From: Liam Griffiths <LiamG@asbriplanning.co.uk>
Sent: 08 July 2021 12:29
To: Roberts, Geraint (Principal Planning Officer) <GeraintN.Roberts@newport.gov.uk>
Cc: thomas.james@engie.com; Emma Harding <emma@asbriplanning.co.uk>
Subject: RE: 20.1242 - Land To South Of Glan Usk Primary School Herbert Road - Remedial Strategy

From the information submitted, it has been noted that the piling method to take place for phase 3 of the development would be bored piling as opposed to the displacement piling used for phase 2. We do not recommend using the bored piling method as there is potential for a new 'preferential' pathway to be created which could lead to the migration of any contamination that may be present.

Figure 1. Risk assessment flowchart

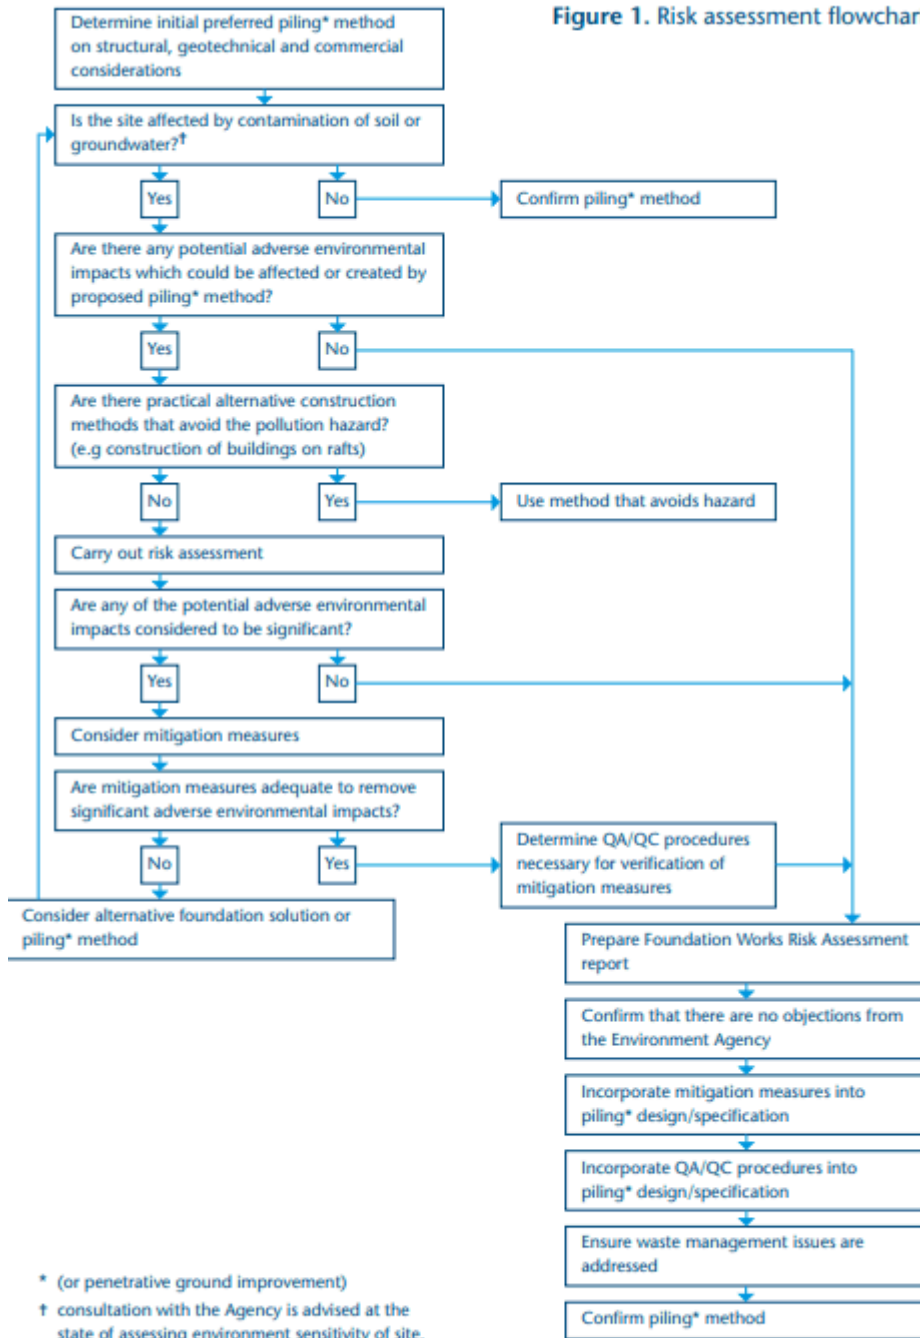
I think we will need you to tick thorough the following process:

If we can go through the risk assessment and show low / no risk to ground and surface waters and public health then fine. But in the first instance you might need to look at another foundation type (raft) and tell us why you can't do that?

If flight auger piling is the only answer then we need some assurance on how pollution pathways either won't be opened up or won't matter if they are.

- 1) Determine initial preferred piling* method on structural, geotechnical and commercial considerations
- 2) Is the site affected by contamination of soil or groundwater? **Yes, please see SI report.**

- 3) Are there any potential adverse environmental impacts which could be affected or created by proposed piling* method? **Yes, Welsh Waters Mainline Trunk sewer. Drawing attached indicating location of Sewer. Drawing attached showing impacted plots**

- 4) Are there practical alternative construction methods that avoid the pollution hazard? (e.g construction of buildings on rafts). **No, Site investigation report compiled by Terra Firma has stipulated a piling solution due to the poor ground conditions wouldn't support a shallow foundation solution. Welsh Water would not accept driven Piles due to their Trunk Sewer being beneath these properties. This trunk sewer is 2.1m in diameter and is running at full bore taking Newport and the surrounding areas sewerage to Newport chemical plant. Bored piles was solely**

- 5) Carry out risk assessment:
- 6) Are any of the potential adverse environmental impacts considered to be significant? **Yes, contamination zone of made ground.**
- 7) Determine QA/QC procedures necessary for verification of mitigation measures: **Van-Elle piling contractor provided RAM's in accordance with mitigating risk when piling. RAM's provided and signed off with Engie Health and Safety department.**
